CITY PLANNING COMMISSION

APPLICATION: Special Permit to allow a duplex in the Single Family Residential (R-1B) Zone.

LOCATION: NE corner 9th Street and W Street

P87-068

SITE PLAN

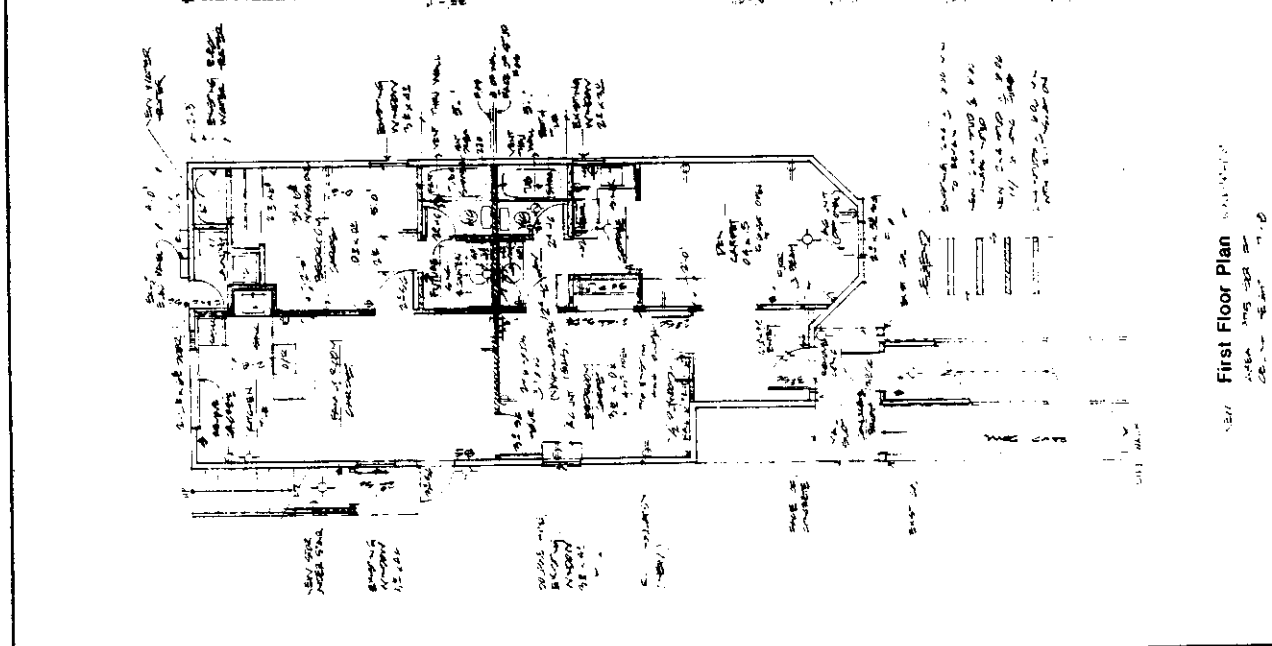
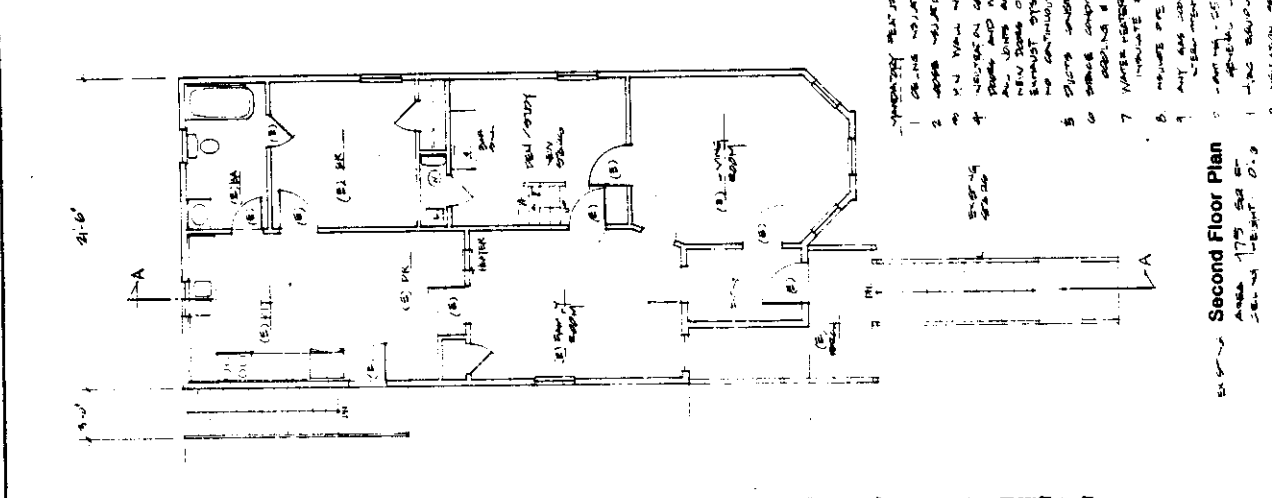
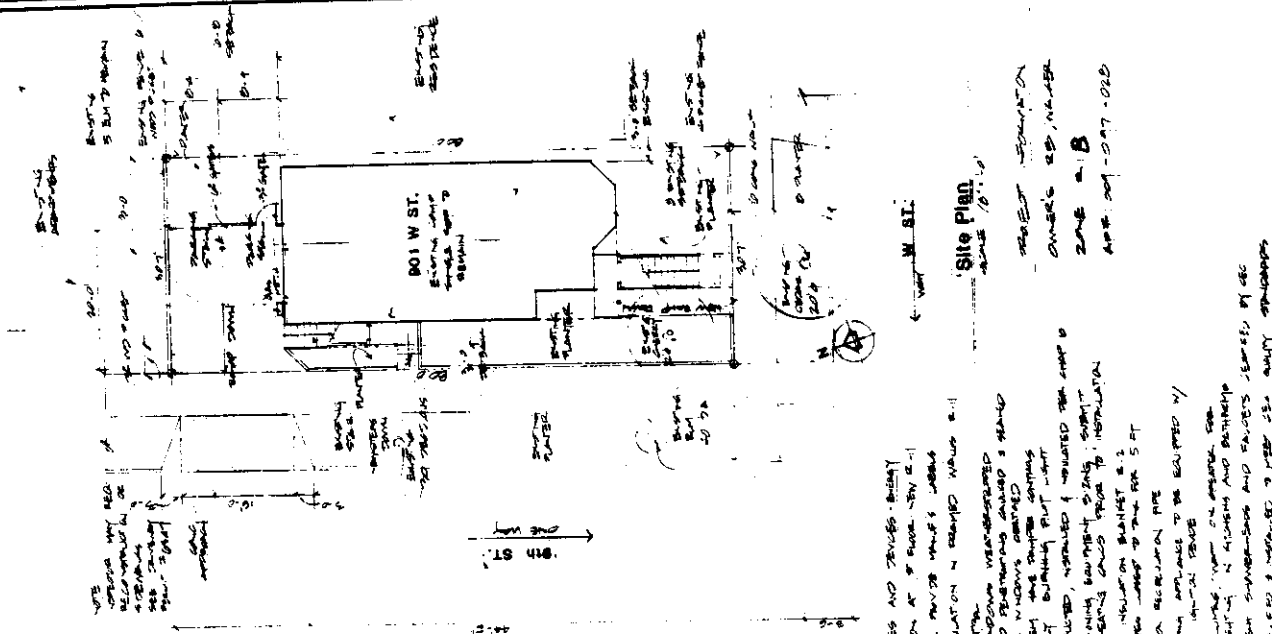
The applicant proposes to provide two on-site uncovered parking spaces located parallel and adjacent to the north property line. (See attached site plan.) The proposed parking area is presently graveled but not paved. The cars would park directly in front of two existing six foot high wood gates. The applicant has indicated these wood gates provide temporary security for the backyard and will be removed prior to completion of the duplex. In addition, the driveway will require a curb cut and driveway permit from the Public Works Department.

Staff recommends the proposed parking area be paved to provide a more permanent parking surface and conform to the current parking standards of the Zoning Ordinance. Two concrete wheel stops should be located two feet from the end of the parking stalls to prevent cars accidentally rolling into the back yard area. (See exhibit A.)

Entire parking surface must be flat (within 3 percent slope)

1. The entire parking surface must be flat (within 3% slope, as required by the City Traffic Engineer.
2. The parking surface shall be paved to the parking standards of the Zoning Ordinance.
3. Two concrete wheel stops, one for each parking stall or a continuous concrete curbing shall be placed two feet from the end of the parking stalls.
4. The applicant shall obtain a driveway permit from Traffic Engineering for the proposed driveway.

Floor plans submitted show two bedrooms located on the first floor and one bedroom on the second floor. A loft area above the second floor is proposed for a future sleeping area, den and bathroom. The applicant should be aware the Zoning Ordinance does not allow the loft to be converted to a third unit. The R-1B zone allows a maximum of two units on a parcel.
